APPLICATION NO.	FILING DATE	FIRST NAMED INVENTOR	ATTORNEY DOCKET NO.	CONFIRMATION NO.
10/727,854	12/04/2003	Craig Andrews	LYNN/0161	7862
24945	7590	02/03/2009		
STREETS & STEELE 13831 NORTHWEST FREEWAY SUITE 355 HOUSTON, TX 77040			EXAMINER WILLS, MONIQUE M	
			ART UNIT 1795	PAPER NUMBER
			MAIL DATE 02/03/2009	DELIVERY MODE PAPER

Office Action Summary	Application No. 10/727,854	Applicant(s) ANDREWS ET AL.	
	Examiner Monique M. Wills	Art Unit 1795

DETAILED ACTION

FIG. 4

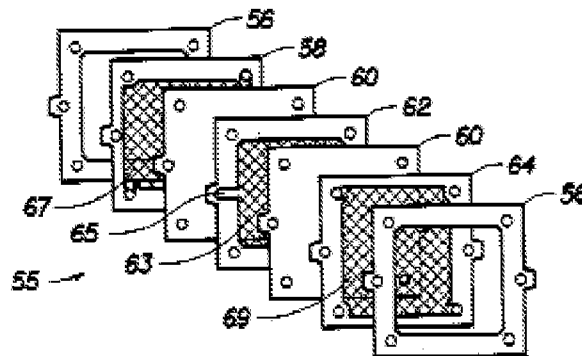
limitations have been considered they do not impart patentability so long as the resulting structure is the same. In the instant case, the bipolar plate of Cisar is identical to Applicants. The anode flow field and the cathode flow field are formed from a material selected from expanded metal mesh (Par. 17). . With respect to the polymer being thermoplastic, it is reasonable to expect the polymer to be thermoplastic as the polymer maintains structural integrity in high temperature fuel cell environments. The polymer includes polyamides. See par. 35. The bipolar plat includes a gas barrier, cathode sealing frame and anode sealing frame. See par. 30. The bipolar plate includes a cooling frame adapted to receive a perimeter of the cathode side of the anode fluid barrier and a perimeter of the anode side of the cathode fluid barrier, wherein an anode side of the cooling frame is bonded to the anode frame to form a fluid seal and the cathode side of the cooling frame is bonded to the cathode frame to form a fluid seal. See par. 35 and Figure 4.

The cooling flow fields are attached to the anode and cathode fluid barriers. See Figure 4 and par. 31 & 32.

However, it would have been obvious to one of ordinary skill in the art at the time the instant invention was made to employ frames around the fluid barrier of Cisar, in order to improve sealing ability of the fluid barrier. Cisar expressly uses of sealing frames around the flow fields as illustrated in Figure 4.

process, determination of patentability is based on the product itself. The patentability of a product does not depend on its method of production. If the product in the product-by-process claim is the same as or obvious from a product of the prior art, the claim is unpatentable even though the prior product was made by a different process.” In re Thorpe, 777 F.2d 695, 698, 227 USPQ 964, 966 (Fed. Cir. 1985). Therefore, the limitation is satisfied because the products are identical. The sealing plates include alignment holes. See Figure 4
